SOLICITATION AMENDMENT MODIFICATION DE L'INVITATION

Title - Sujet Designated Support Space	
Solicitation No. - N° de l'invitation ED001-172941/A	Amendment No. - N° modif. 003
Client Reference No. - N° de référence du client R.086261.003	Date 2017-02-23
GETS Reference No. - N° de référence de SEAG PW-\$PWC-008-4093	
File No. - N° de dossier PWC-6-39194 (008)	CCC No./N° CCC - FMS No./N° VME
Solicitation Closes - L'invitation prend fin at - à 02:00 PM on - le 2017-03-01	
Time Zone Fuseau horaire Atlantic Standard Time AST	
F.O.B. - F.A.B. Plant-Usine: <input type="checkbox"/> Destination: <input checked="" type="checkbox"/> Other-Autre: <input type="checkbox"/>	
Address Enquiries to: - Adresser toutes questions à: Reay, D (PWC)	Buyer Id - Id de l'acheteur pwc008
Telephone No. - N° de téléphone (902) 566-7518 ()	FAX No. - N° de FAX (902) 566-7514
Destination - of Goods, Services, and Construction: Destination - des biens, services et construction:

The following changes in the tender documents are effective immediately. This addendum will form part of the contract documents.

This Addendum is raised to provide the following answers to questions provided by bidders (Site Visit, Februar

FLOOR PLAN REVISIONS

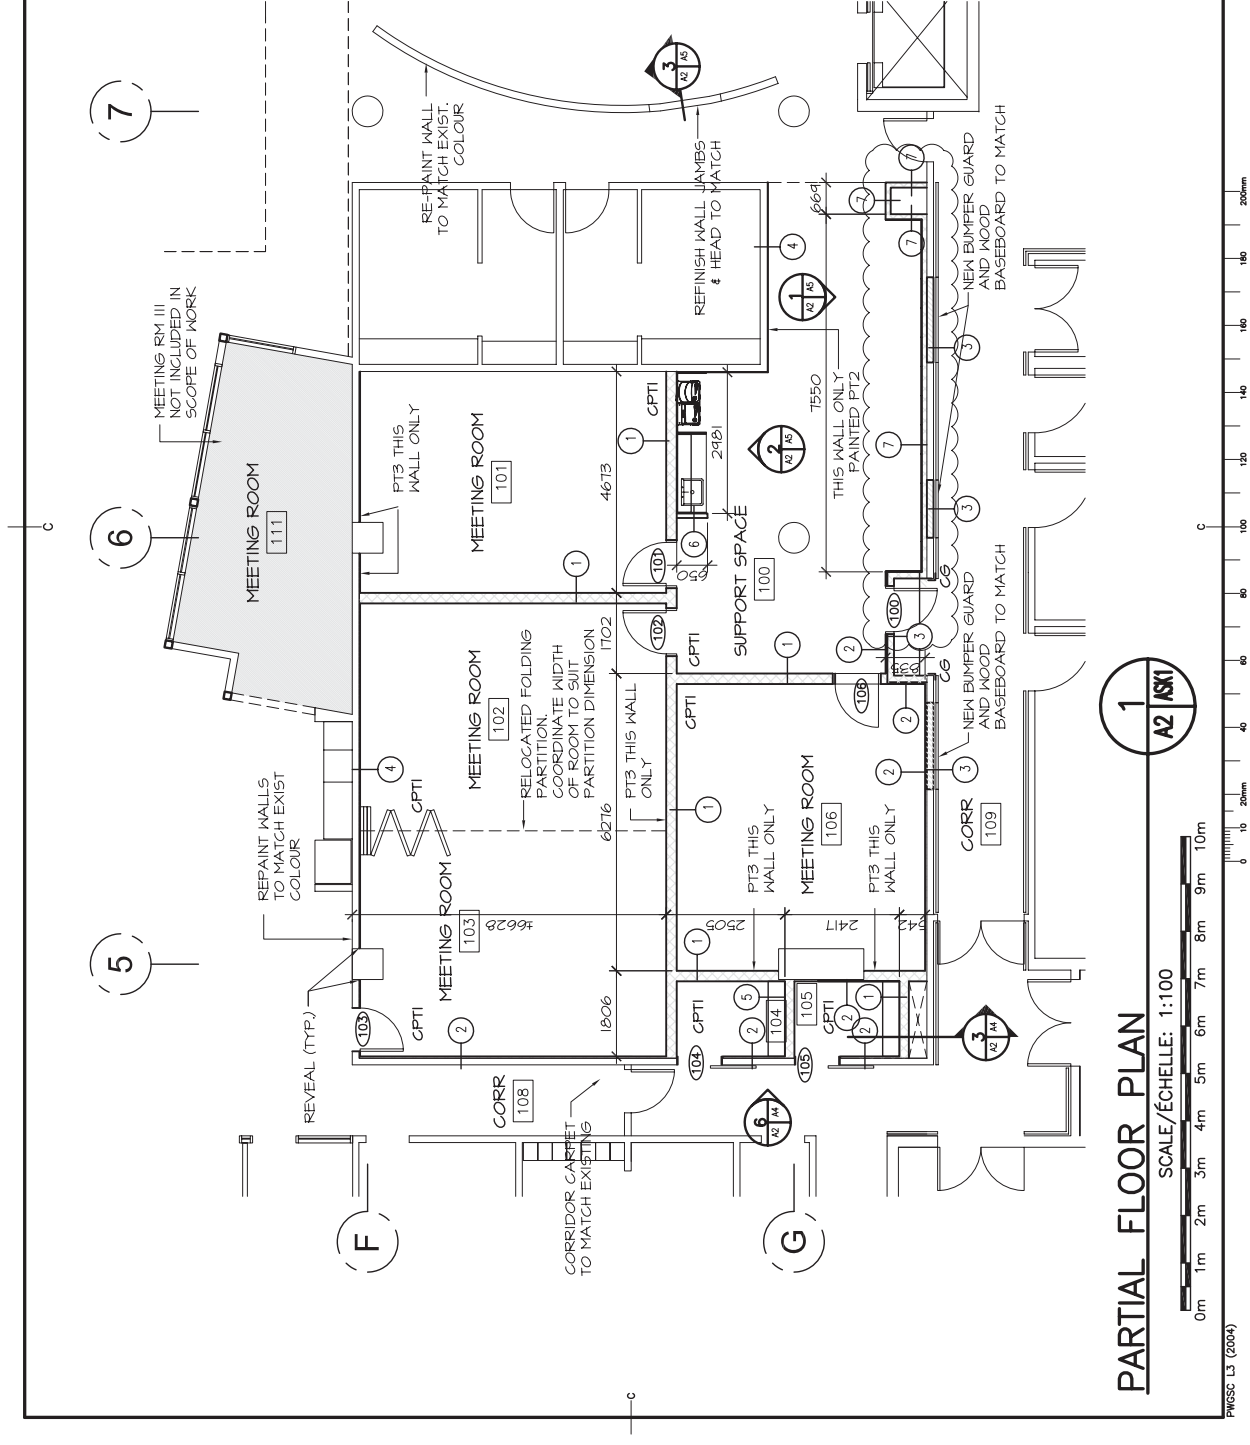
- .1 Ref. Drawing A2 – Detail 1/A2/A2
 - .1 Replace detail entirely with appended sketch 1/A2/ASK#001.
 - .2 Delete requirement for door 100A and associated closet.

- .3 Extend wood surround into former Closet space
 - .4 Revise location of page right wall of alcove associated with Door 100 to the right as required to facilitate 610mm equal wood panel dimensions.

- .5 Furr out page south wall behind wood paneling with a continuous type W7 wall to accommodate new electrical services. Decrease depth of panel assembly to suit.

- .6 Allow for cutting and repair of existing suspended concrete slabs to accommodate installation of new recessed floor boxes indicated within the body of this addendum below.

CEILING PLAN
REVISIONS

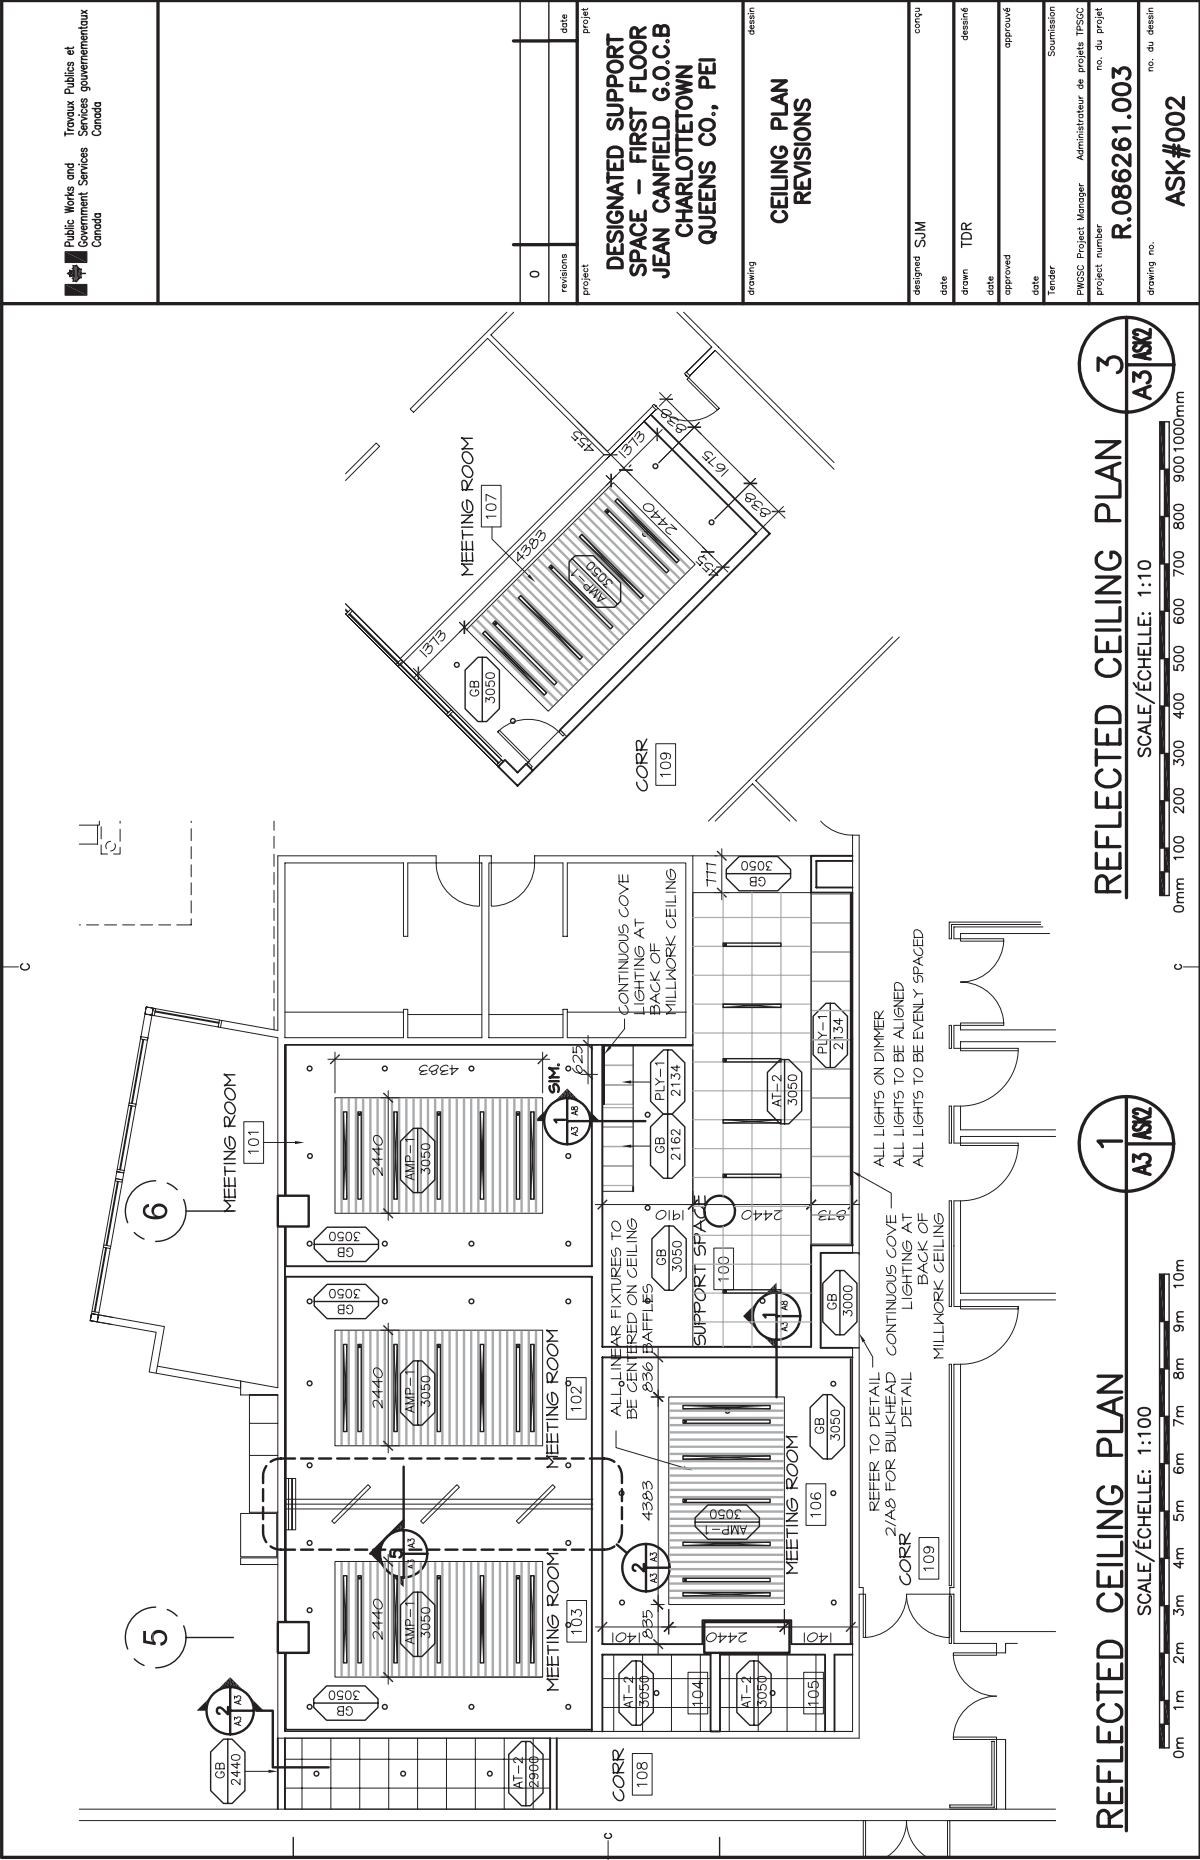
- .2 Ref. Drawing A3 – Detail 1
 - .1 Replace detail entirely with appended sketch 1/A3/ASK#002. Note revisions to ceiling dimensions, and types throughout.

- .3 Ref. Drawing A3 – Detail 3
 - .1 Replace detail entirely with appended sketch 3/A3/ASK#002. Note revisions to ceiling dimensions, and types throughout.

BENCH DETAILING

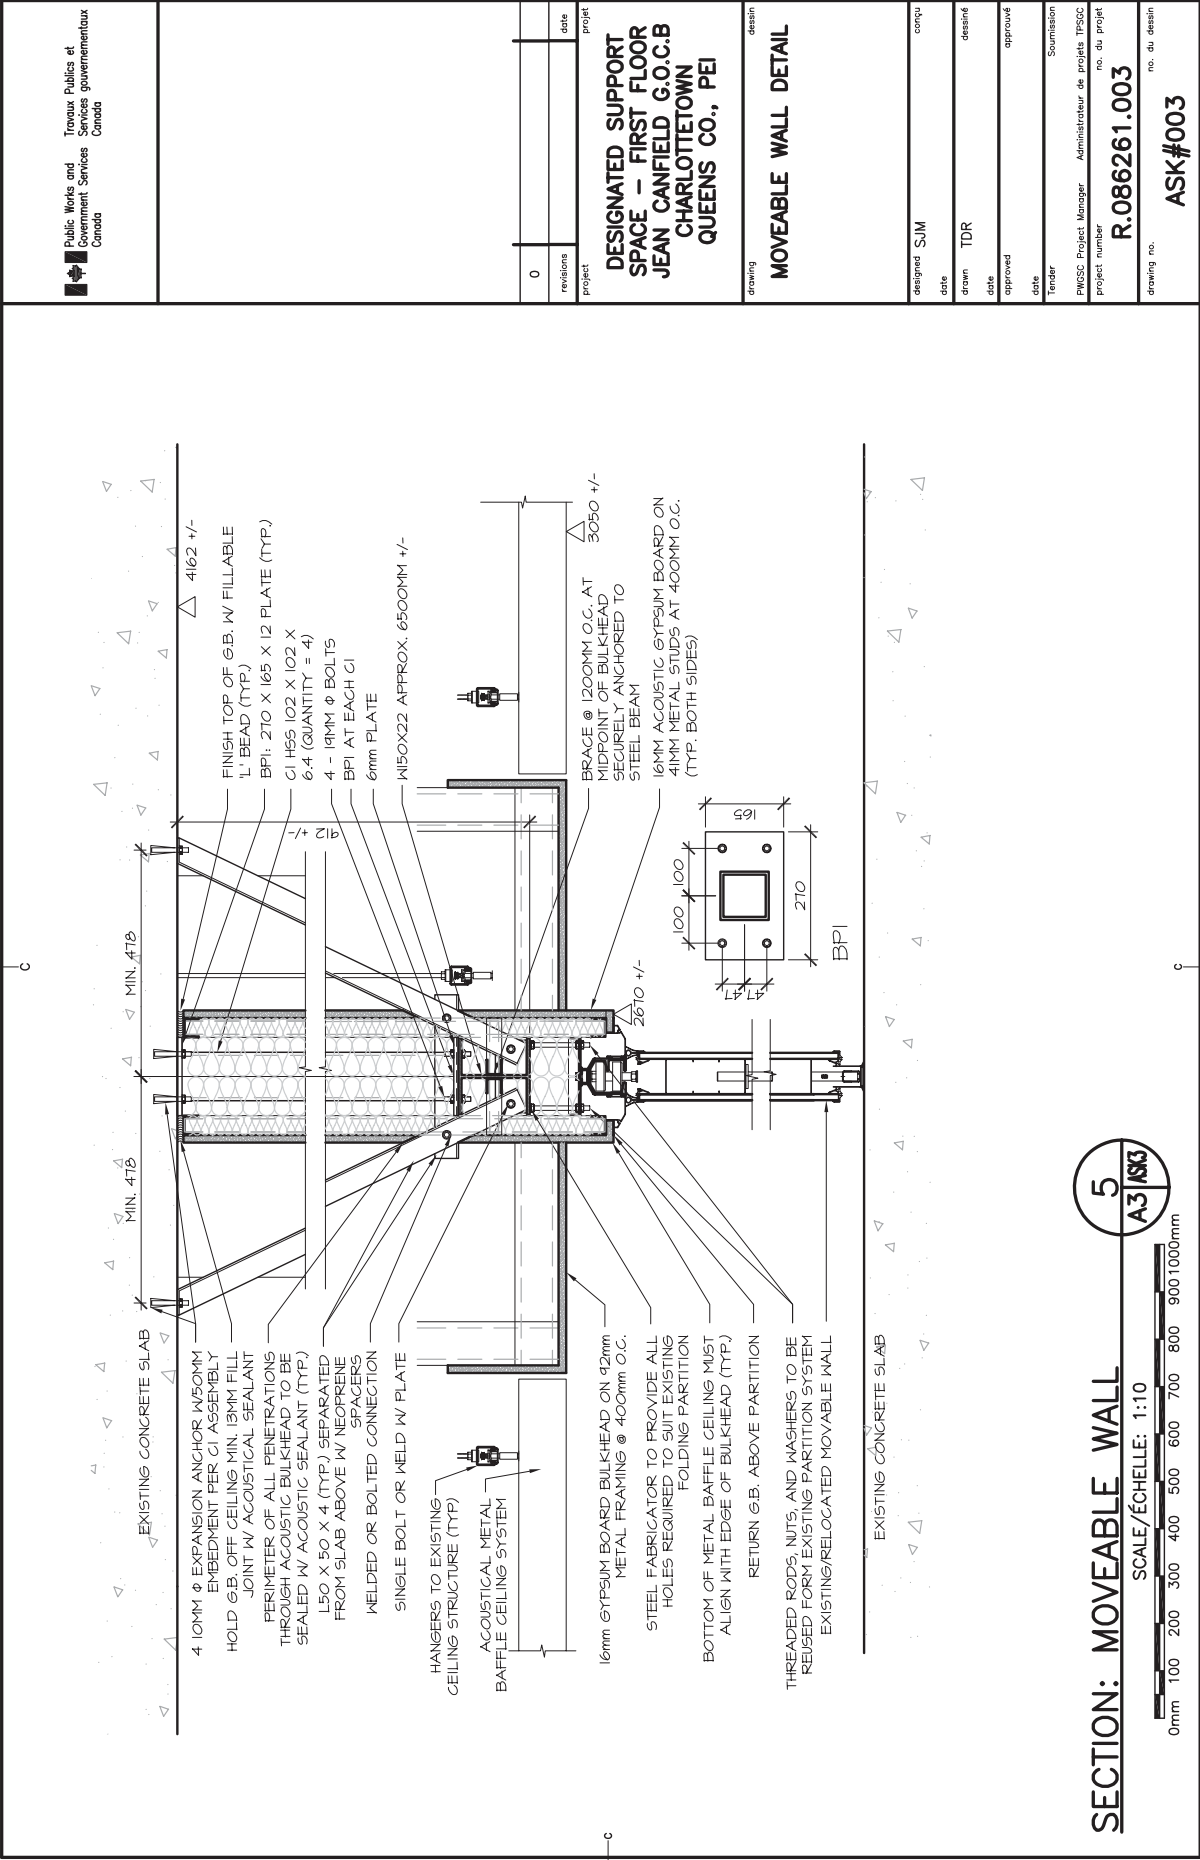
- .4 Ref. Drawing A3 – Detail 5
 - .1 Replace detail entirely with appended sketch 5/A3/ASK#003
- .5 Ref. Drawing A4 – Detail 1
 - .1 Delete door type D3
 - .2 Dimensions of style and rail of door D4 to be 200mm each.
